CITY OF PORTLAND

Permit Number: 091386

has permission to install hood system

AT 25 FOREST AVE CBL 037 A022001

KITAHON Rest.
Forest Ave
PORTLAND Me
contractor: Lebel's Sheet Metal
Contact: PAUL ROY
TEL: 207-782-2235
CELL: 576-1863

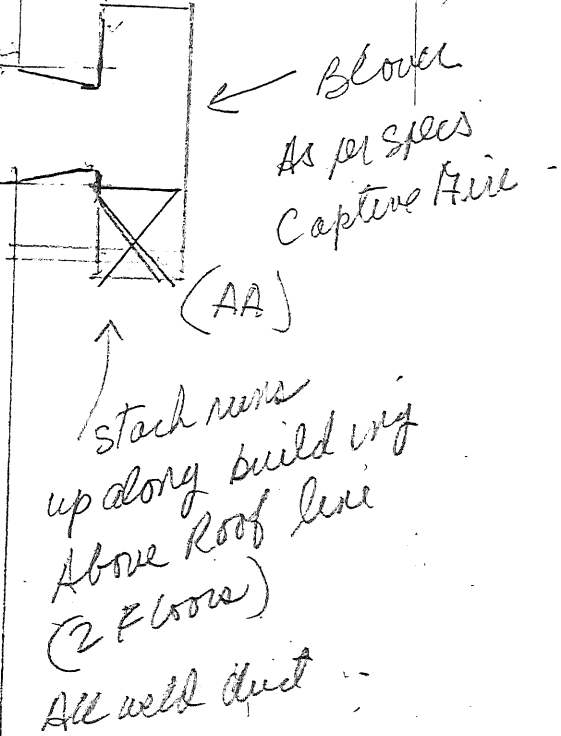
1/19/2010-jmb: Left vmsg with Paul R. For floor plan showing where the hood and equipment is, the height above the hood and cleanouts. Paul left vmsg about 0 clearance wrap above hood and around duct. Ok to issue

per Paul R.
0 clearance
at ceiling

Kulander Rest
Paul Roy / Lebel's Sheet Metal
576-1863

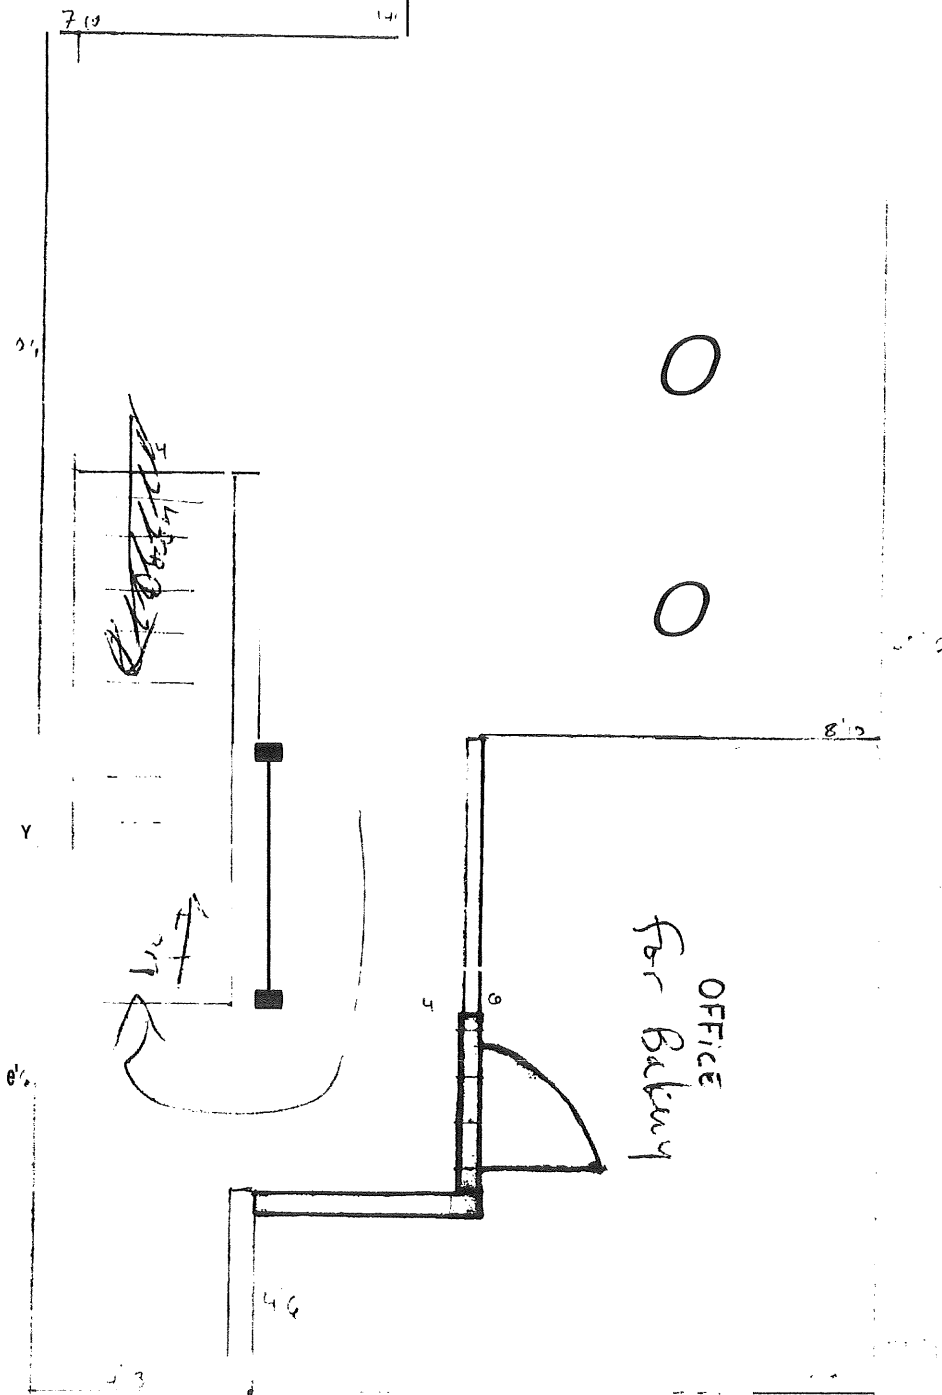
Dept: Historic **Status:** Approved **Reviewer:** Scott Hanson **Approval Date:** 12/21/2009
Note: Left message on 12-14 for Paul Roy @ Lebel's Sheet Metal, informing him that I need a photo with the location of the proposed ductwork on the building marked or indicated. I also offered to meet on site to see the ocation if that would be easier. **Ok to Issue:**
 Requested information delivered on 12/21.
